**REQUEST FOR PROPOSALS (RFP)
Responses to Written Questions**

**Digital Communications System
P25 Radio Equipment
& Services**

**Kitsap 911
Kitsap County, Washington**

Responses to Written Questions

Figure S-2 Zetron ACOM System Overview

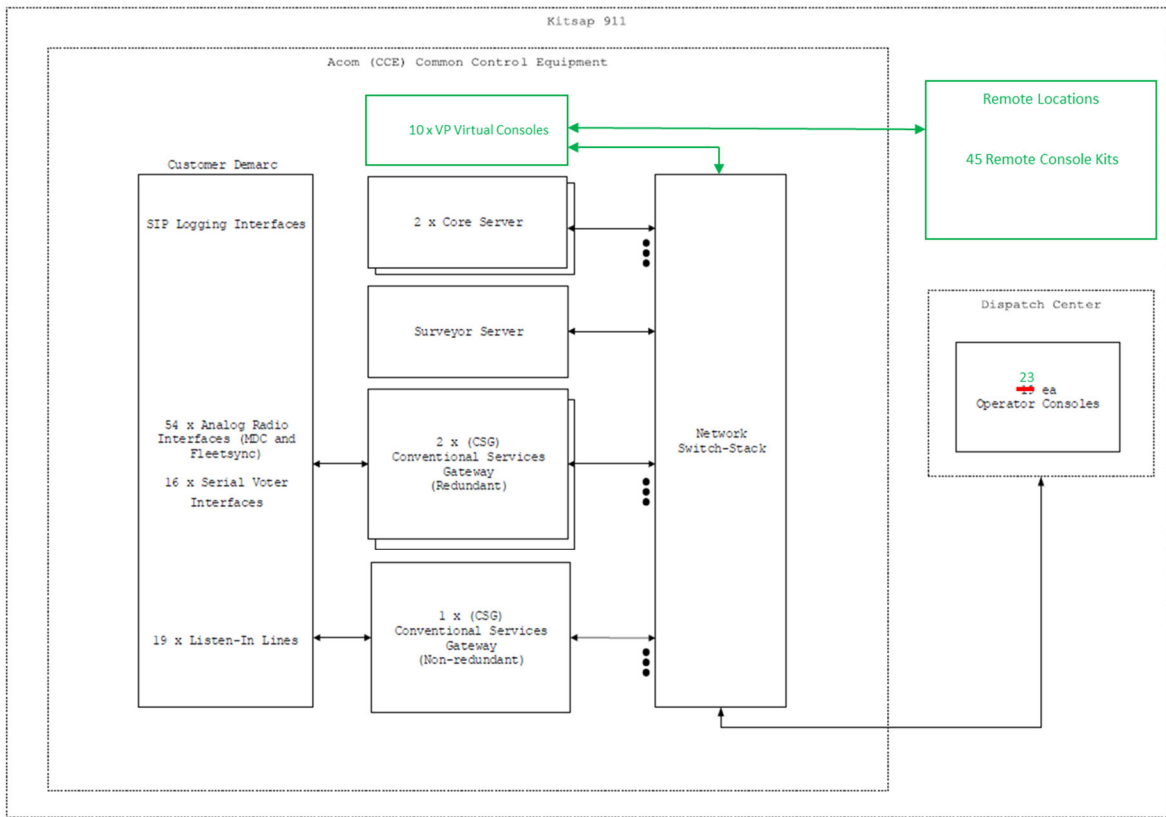
The response to one of the questions, prompted Kitsap 911 to provide supplemental information on the dispatch console system. The supplemental information is provided after the table of responses.

Replace the entire section 1.18 in the Existing System Description with the following:

Replace sections 1.23.1 and 1.23.2 in the Existing System Description with the following:

1.23.1 The Kitsap 911 dispatch console system is a recently upgraded, redundant Zetron AcomNovus system located at the 911 Carver St., Bremerton, WA 98312. Figure S-2 shows the System Overview diagram consisting of redundant core servers, a reporting (Surveyor) server, two redundant conventional services gateways, one non-redundant conventional services gateway (for listen-in lines), and the Ethernet switches. The diagram also shows the 23 operator consoles in the Dispatch Center and 20 virtual consoles supporting 45 remote consoles.
